Access Compliance Report

Public Rights-of-Way

Intersection ID: 28584	Main Street: FALCONCREST_DR	Cross Street: HIGHLAND_CREEK_PY	Location: SW
ADA ID: 4BC4EF8AE0DF	Ramp Type: PerpDiag	Initial Pass/Fail: Pass	Overall Compliance: No
		Severity Score: 4

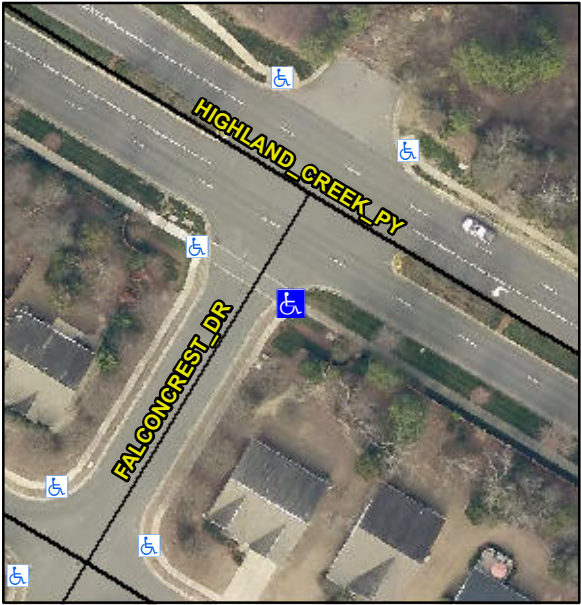
Codes/Mitigation Info/Possible Solution		Field Measurements/Component Compliance			
	Possible Solutions:				
	Remove & Replace Curb Ramp With Two New Directional Ramps or Equivalent.				
	Surveyor Notes:				
	N/A				
	PROW/ADA:				
	Not Found, R304.2.1, R304.2.2-Perp, R304.3.2-Para, R304.5.3, R305.2				
	Street 1 Name	HIGHLAND CREEK PY		Stop Condition-Street 2	None
	Street 2 Name	FALCONCREST DR		Stop Condition-Street 1	StopSign
	Total Cost:	\$	3200.00		
Compliance	Description	Data	Compliance	Description	Data
N/A	Ramp Length (in)	42.0	Yes	Ramp Slope (%)	5.1
Yes	Ramp Width (in)	54.0	Yes	Ramp XSlope (%)	1.4
N/A	Flare Type LT	Sloped	N/A	Flare Type RT	N/A
N/A	Flare Slope LT (%)	1.4	Yes	Flare Slope RT (%)	5.2
N/A	Flare Traversable LT?	Yes	N/A	Flare Traversable RT?	Yes
No	Landing Length (in)	44.0	Yes	DWS Provided?	Yes
No	Landing Width (in)	44.0	Yes	DWS Contrast?	Yes
No	Landing Slope (%)	3.5	Yes	DWS Length (in)	25.0

No	Landing X Slope (%)	3.4	Yes	DWS Full Width?	Yes
N/A	Landing Curb? (Y/N)	No	No	DWS Offset (in)	3.0
N/A	Shared Landing?	No			
Yes	Gutter Ponding?	No	Yes	Gutter Slope (%)	1.6
Yes	Gutter Lip Ht (in)	0.0	Yes	Gutter X Slope (%)	1.2
N/A	Painted X Walk1?	No	N/A	Painted X Walk2?	Yes
	X Walk 1 Direction	To NE		X Walk 2 Direction	To NW
N/A	X Walk 1 Width (in)	N/A	N/A	X Walk 2 Width (in)	96.0
	X Walk 1 Slope (%)	0.5		X Walk 2 Slope (%)	0.5
	X Walk 1 X Slope (%)	0.5		X Walk 2 X Slope (%)	1.1
N/A	Ramp inside XWalk1?	N/A	Yes	Ramp inside XWalk2?	Yes
	Road Slope (%)	0.9	N/A	Clear Space?	Yes
	Road X Slope (%)	0.4	N/A	Clear Space to XWalk (in)	N/A
Yes	Any Obstructions?	No	Yes	Storm Grate/Utility Hazard?	No
	Obstruction Type			Storm Grate/Utility Type	
		N/A			N/A
			Yes	Surface Condition? (G/P)	Good
